To	Richard Feinberg, PPG	Page	1
CC	Tom Gibbons (CB&I), Scott Mikaelian (AECOM); Site 174 – Dennis Collins Park, Bayonne, NJ		
Subject	RAWP Addendum - Additional Remedial Investigation Activities to Assess Extent of Visible CCPW		
From	Al LoPilato, AECOM		
Date	June 26, 2013

**PROPOSED
 TEST HOLE LOCATIONS
 SITE 174**

FIGURE 1

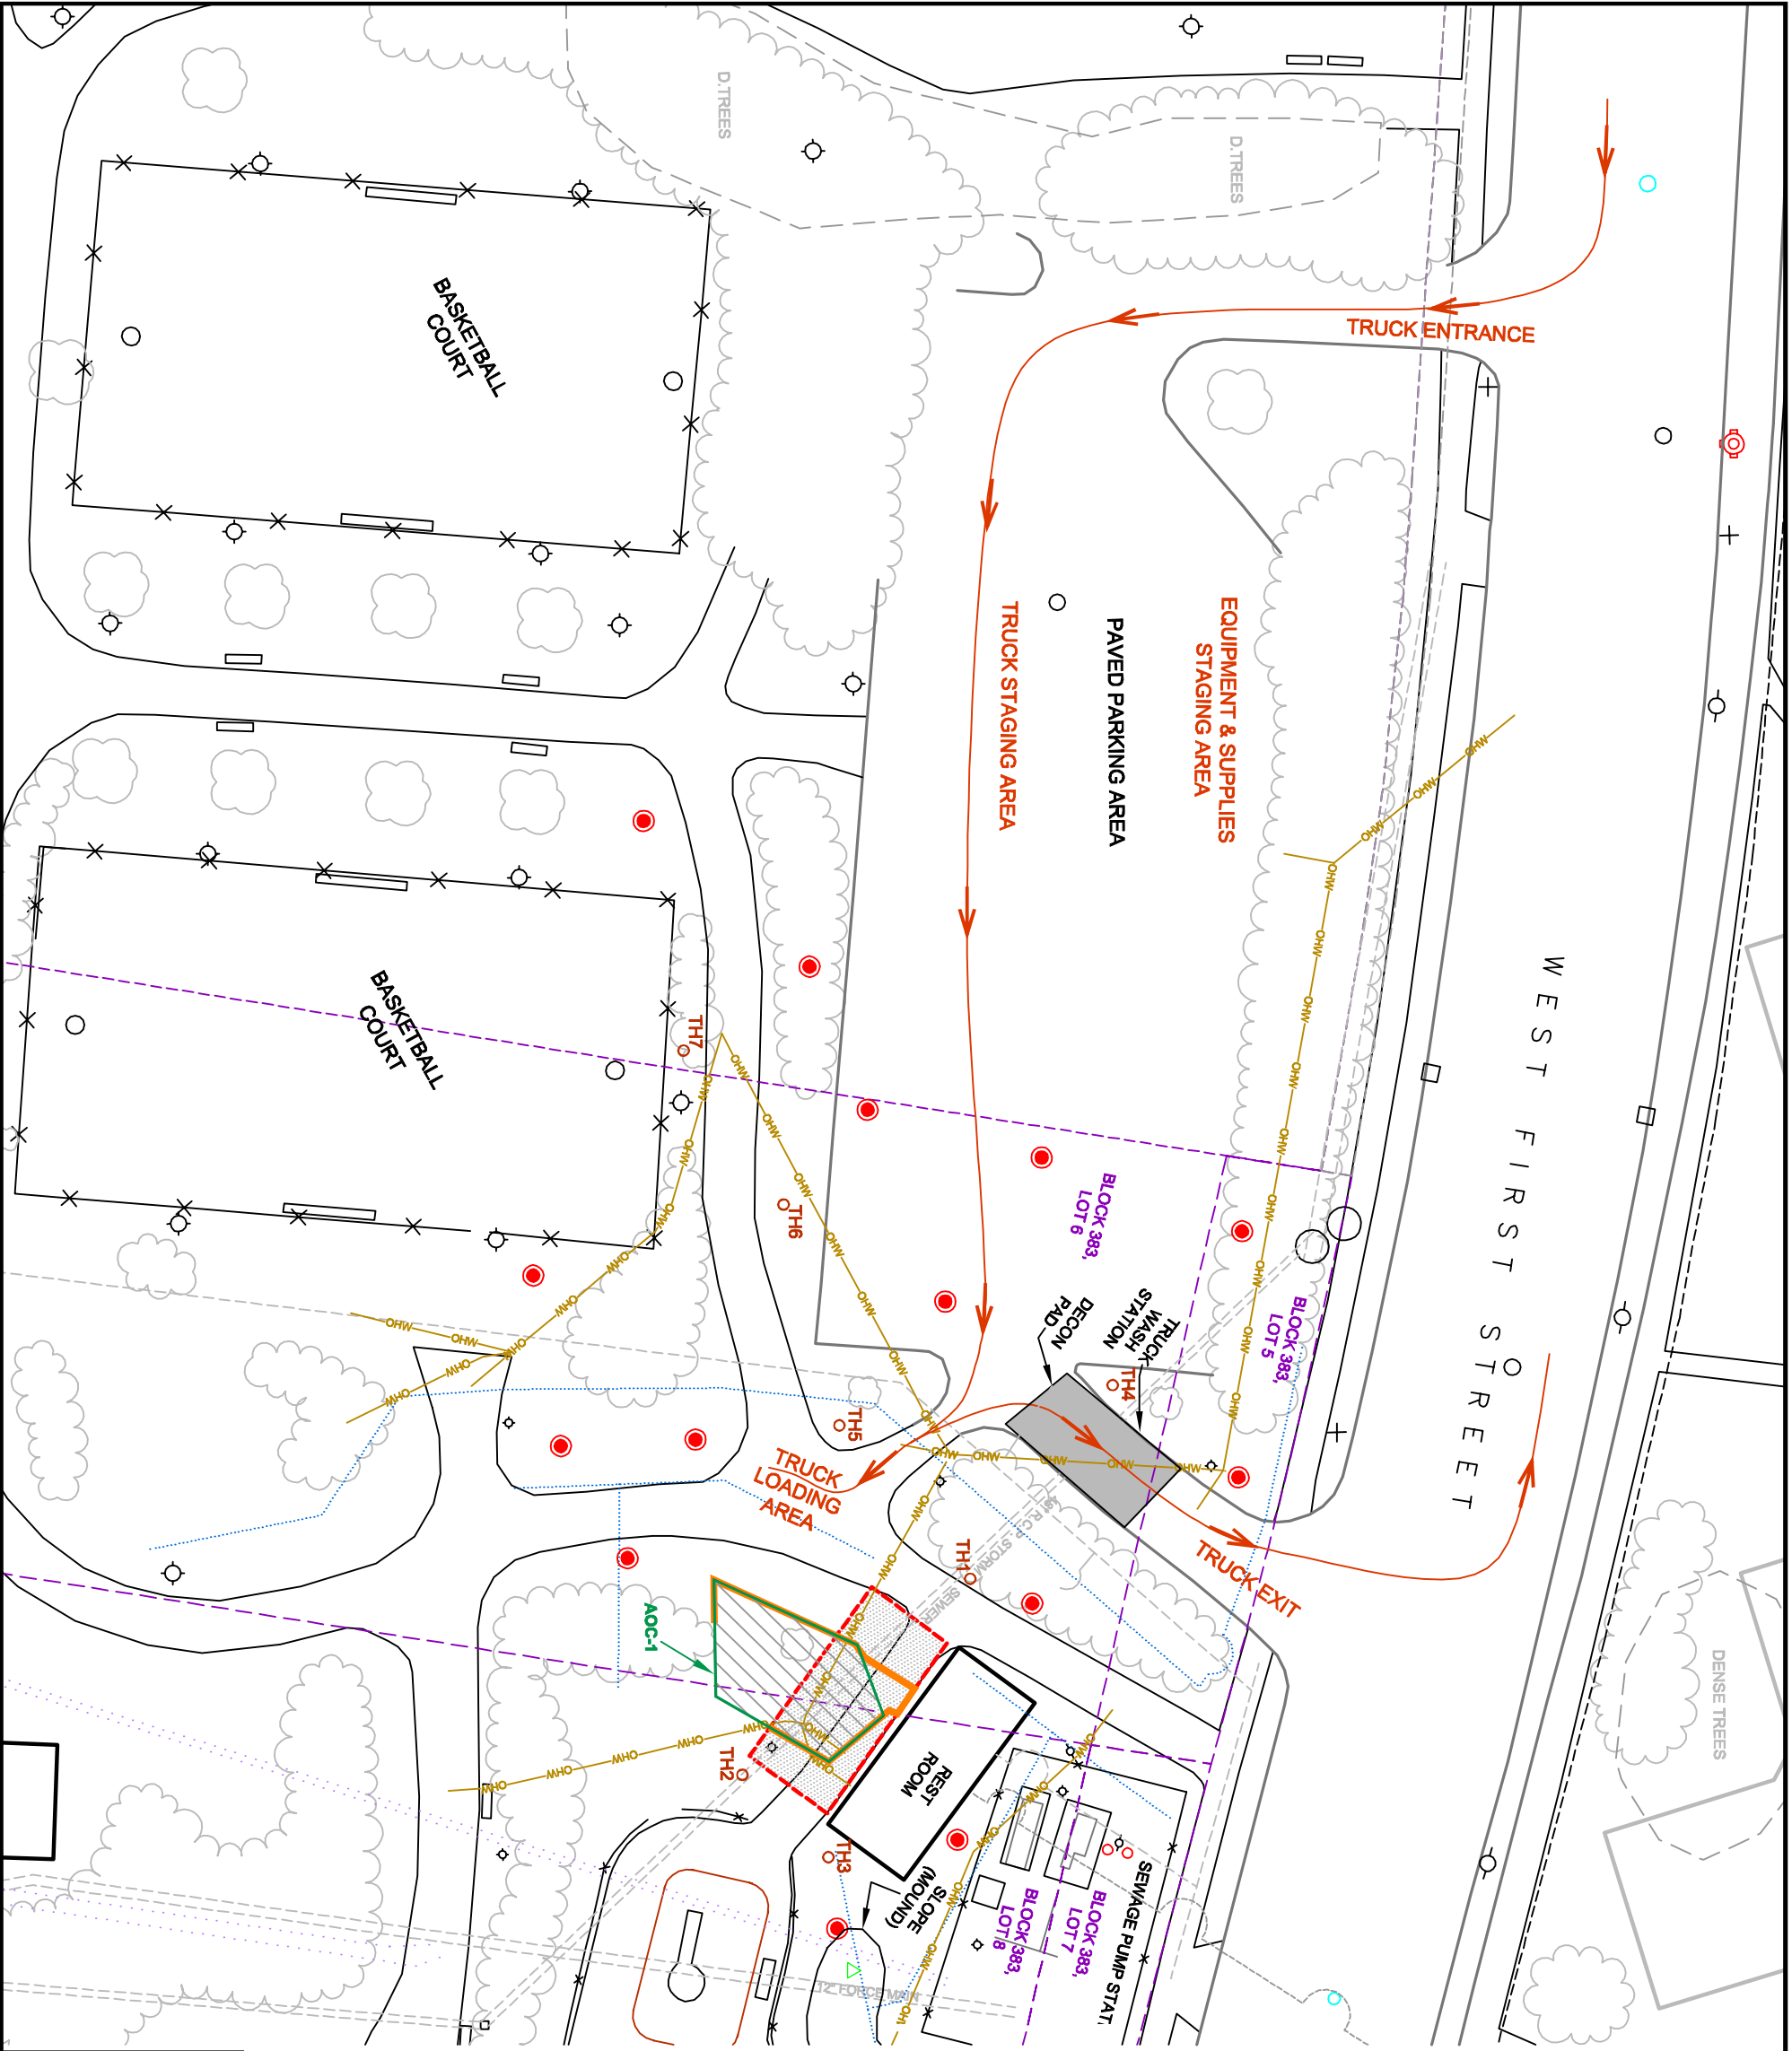
The purpose of this additional Remedial Investigation (RI) is to delineate the areal extent of visible CCPW material, which was previously encountered beyond the proposed excavation limits during the initial soil remedial action activities on April 8, 2013. As depicted on attached Figure 1, and as discussed with PPG, NJDEP and Weston on a conference call on June 3, 2013, at least 14 additional test holes will be advanced to further assess the extent of visible CCPW at Site 174. In addition, AECOM plans to manually advance via hand-auger one soil boring in the landscape berm adjacent and north of the playground area.

As discussed with NJDEP, these proposed field activities will generally be conducted pursuant to the requirements of the previously approved Remedial Action Work Plan (RAWP). The work will be implemented in discrete, small areas of investigation (exclusion zones) at each of the delineation locations proposed on Figure 1.

*TH6 APPROXIMATELY 65' WEST OF EXCAVATION LIMIT. COPR SEAM APPEARS TO BE THINNING OUT AT TH3 AND TH4. COPR SEAM ENDS 2 FEET SOUTH OF THE REST ROOM
